CONSTRUCTION PLANS
FOR
**PONDEROSA AT
LORSON RANCH FILING NO. 3**
STREET/STORM SEWER AND UTILITY CONSTRUCTION PLANS

COVER SHEET
STREET/STORM SEWER
AND UTILITY PLANS

PUDSP-19-010

SHEET NUMBER
C0.1

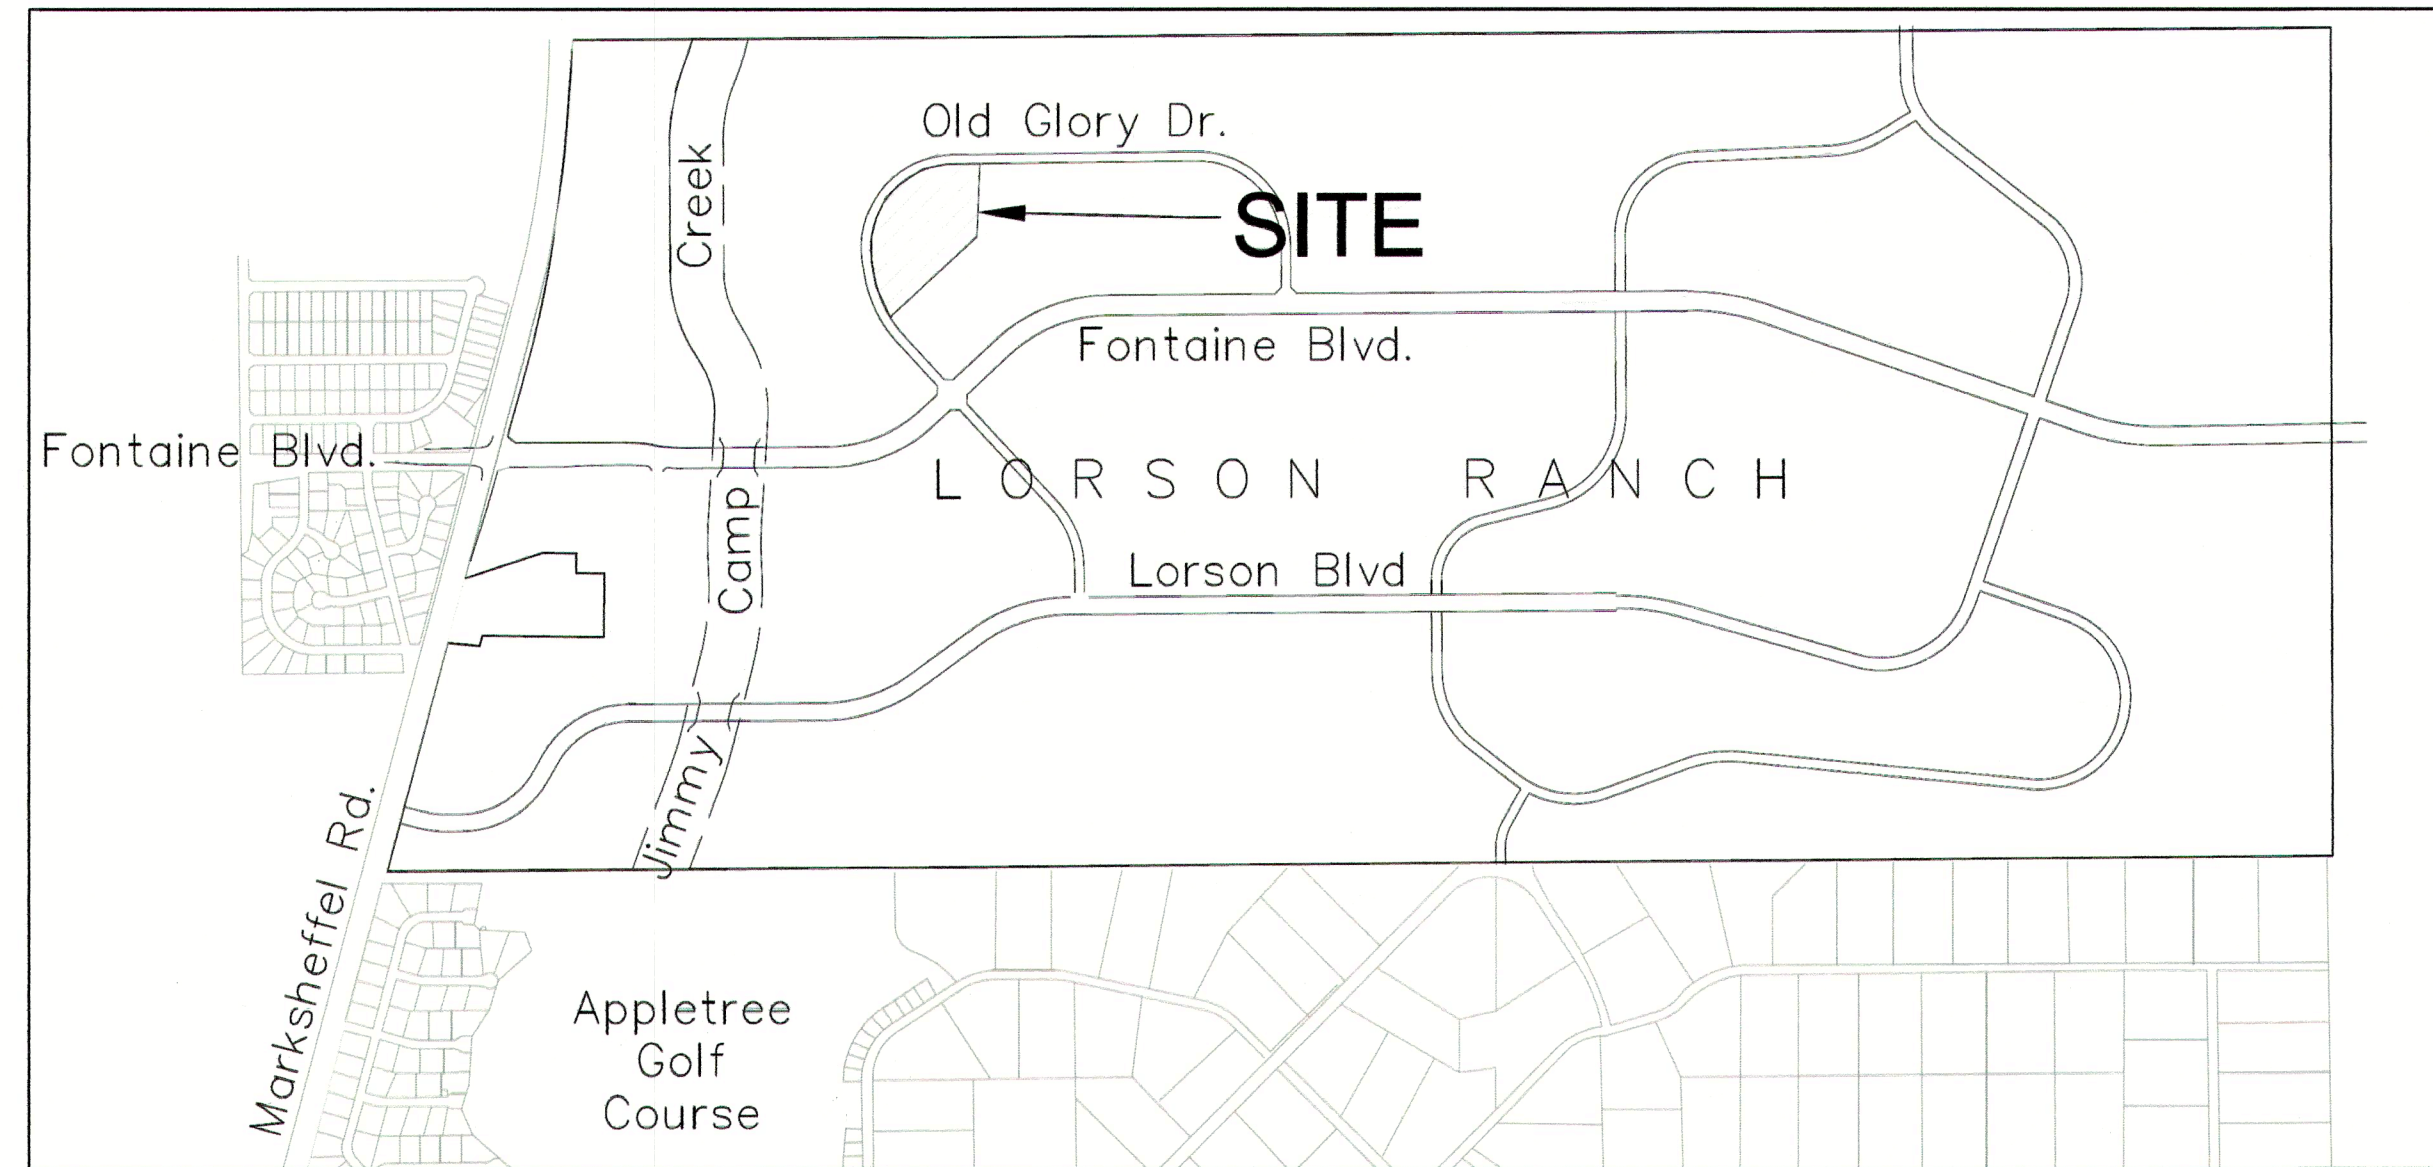
Update legend to
include all line types
and symbols used.

address PUDSP
comments first

DATE: APR 8, 2020
 PROJECT NO: 100.050
 SHEET NUMBER: C2.1
 TOTAL SHEETS: 30

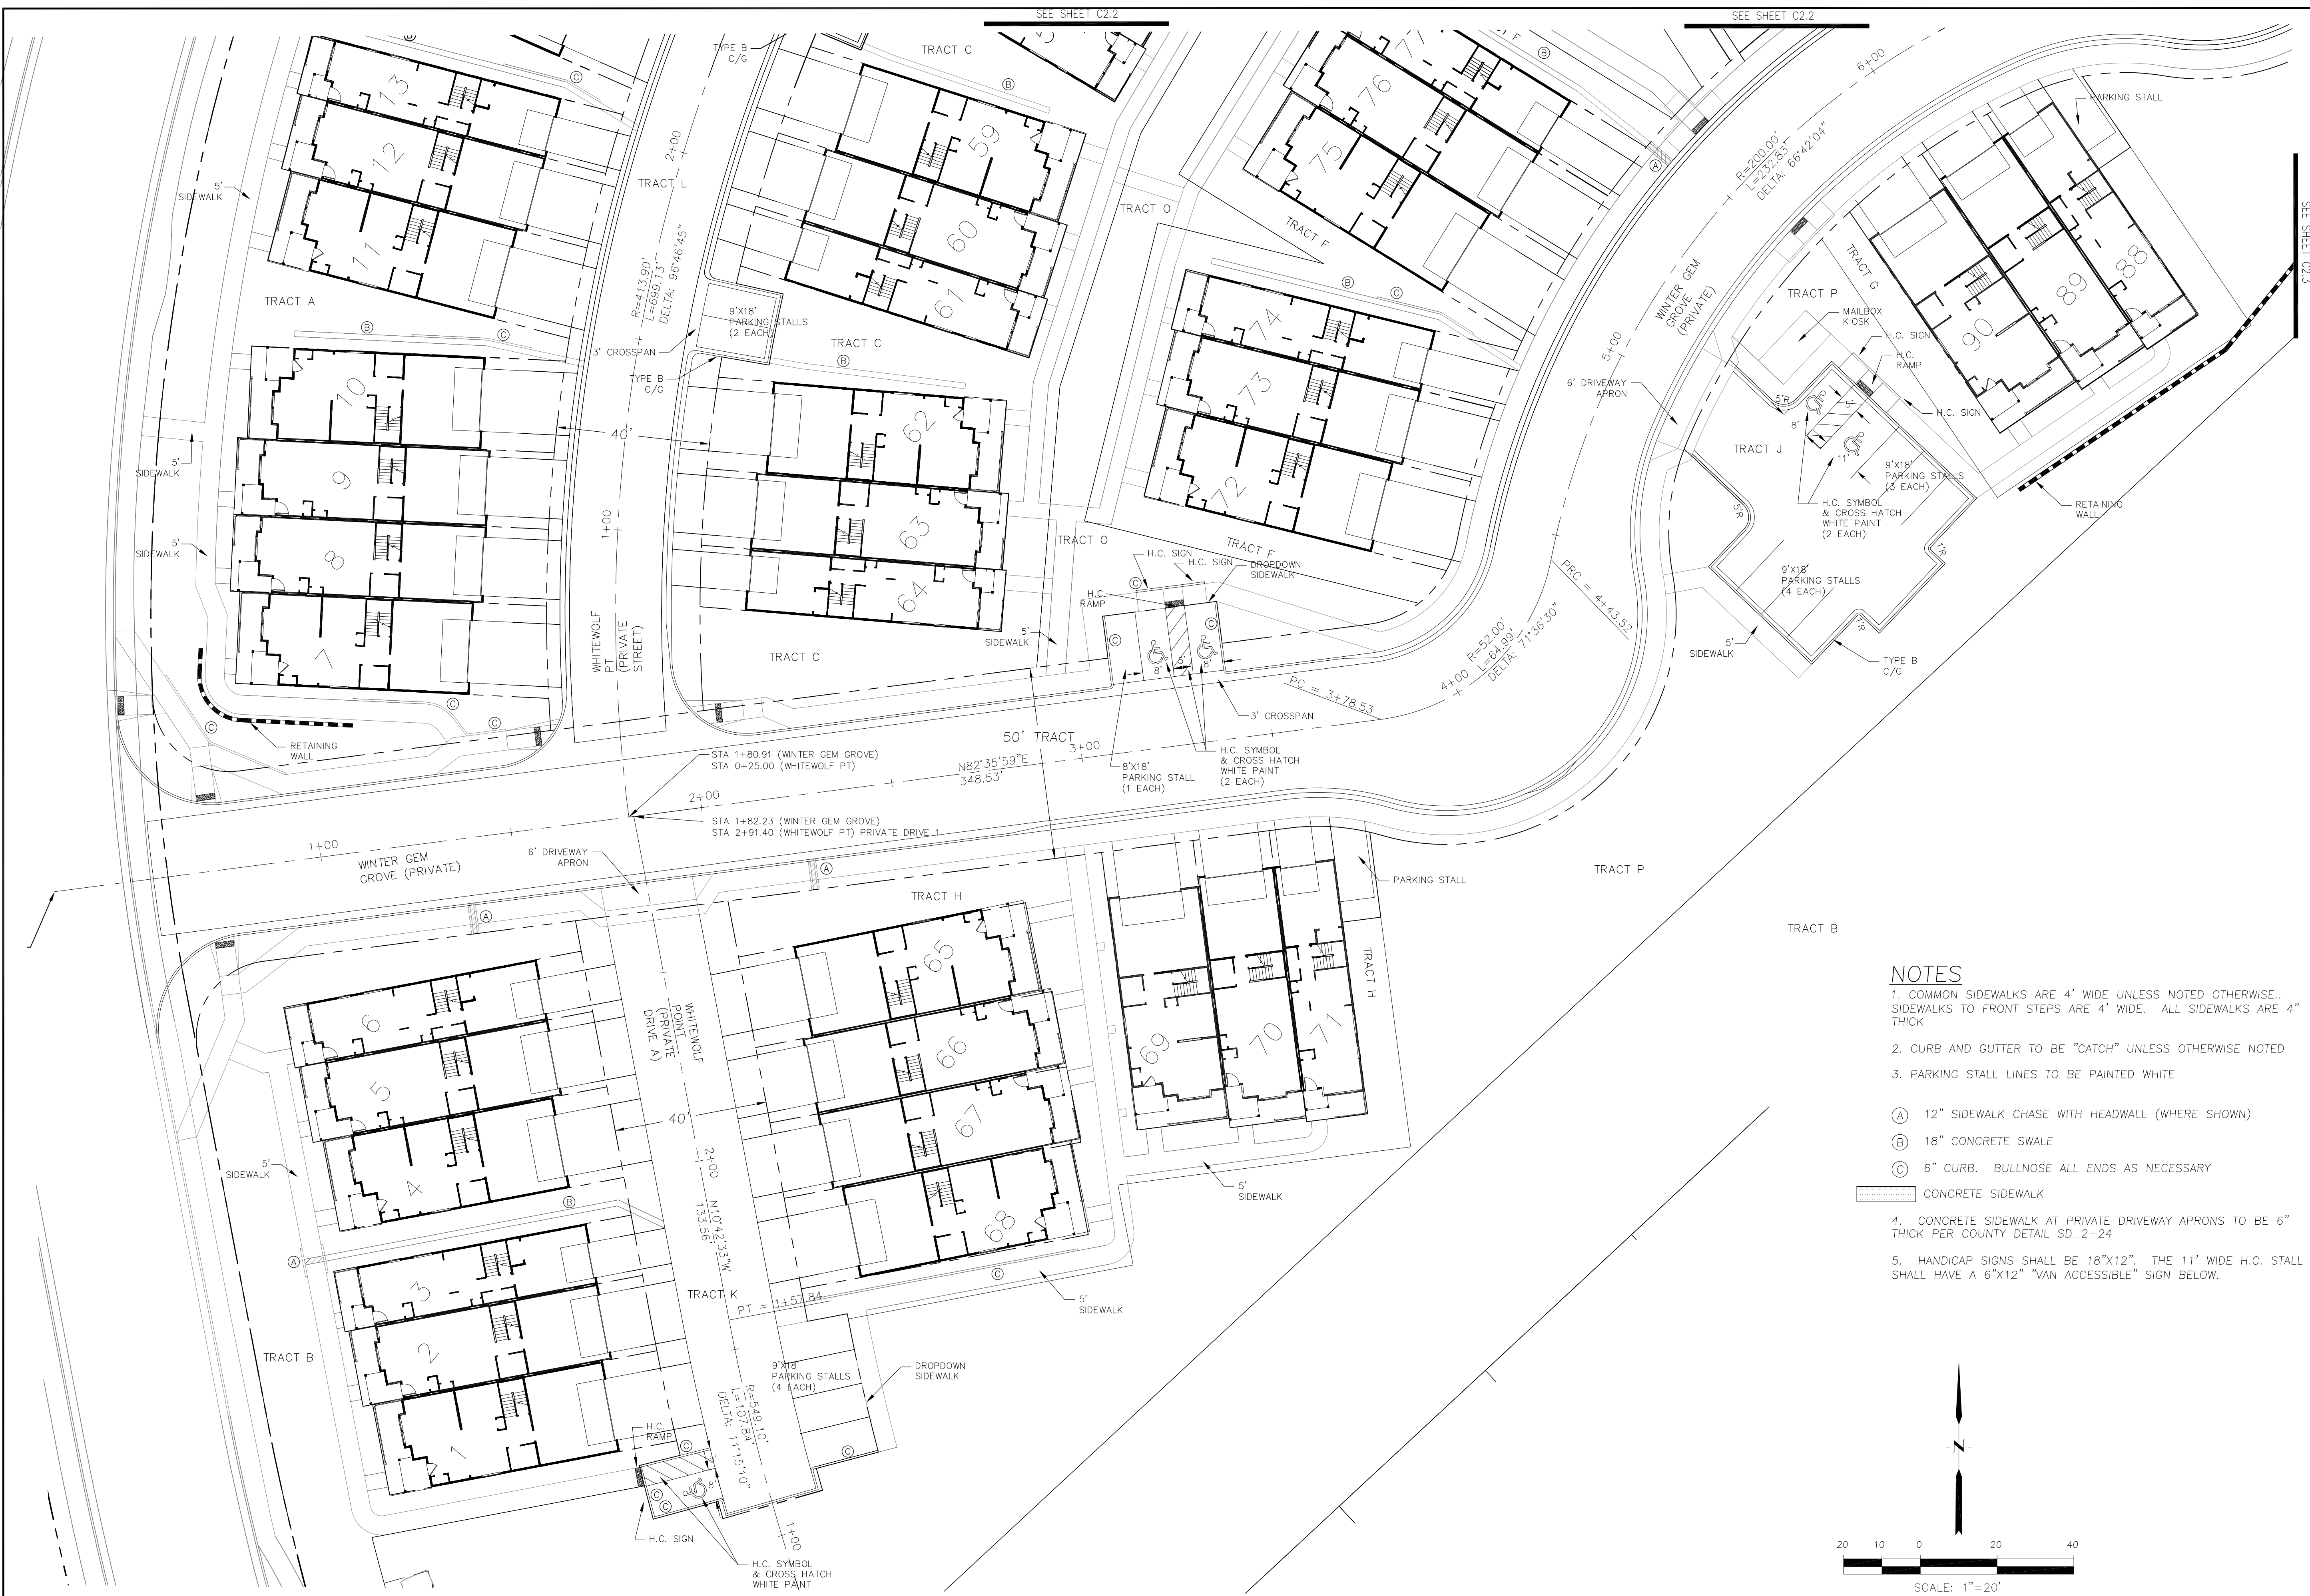
Update. Hatch is missing from the plans.

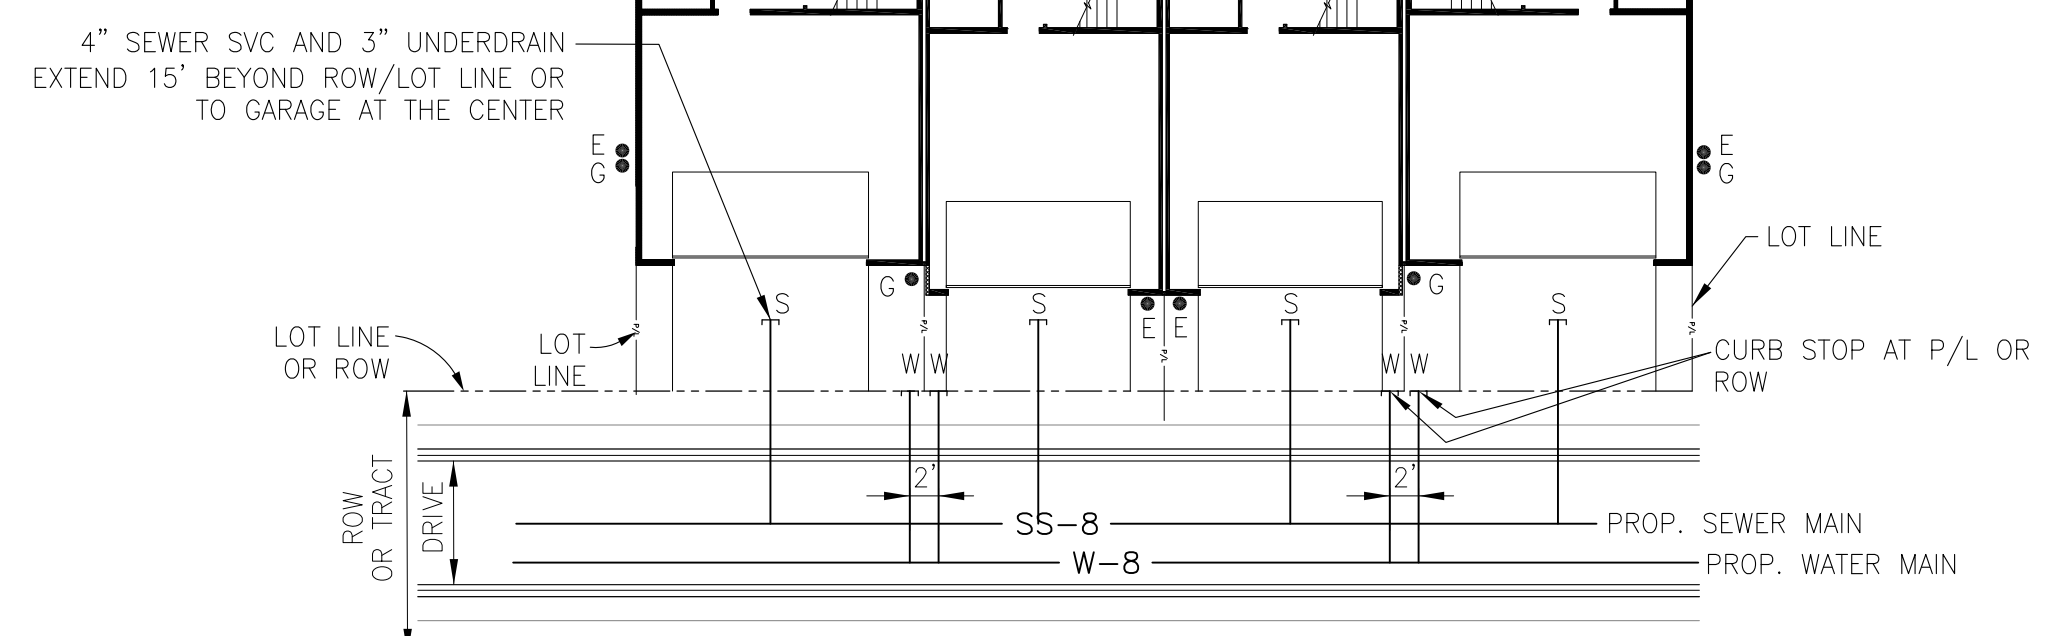
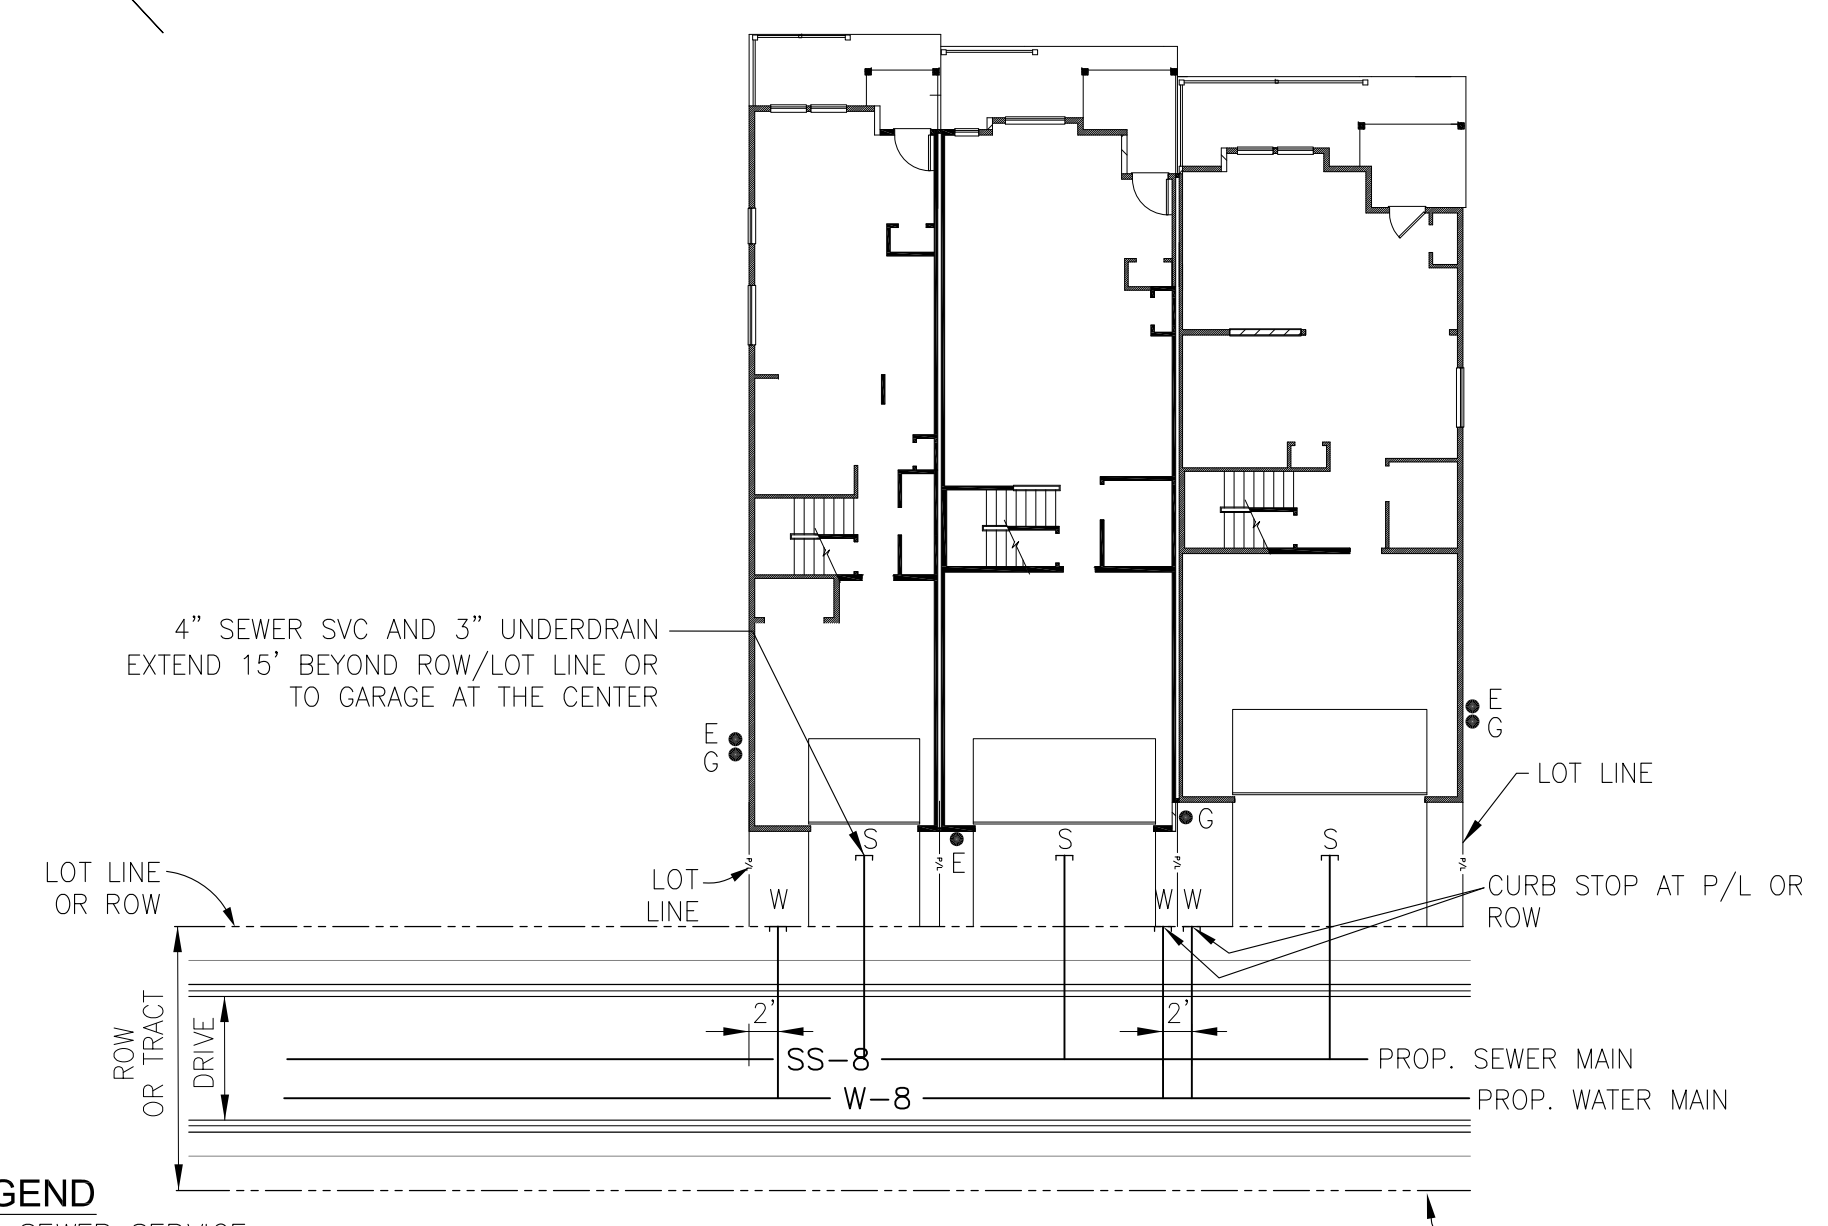
Add the dash-dot-dot line type to the legend.
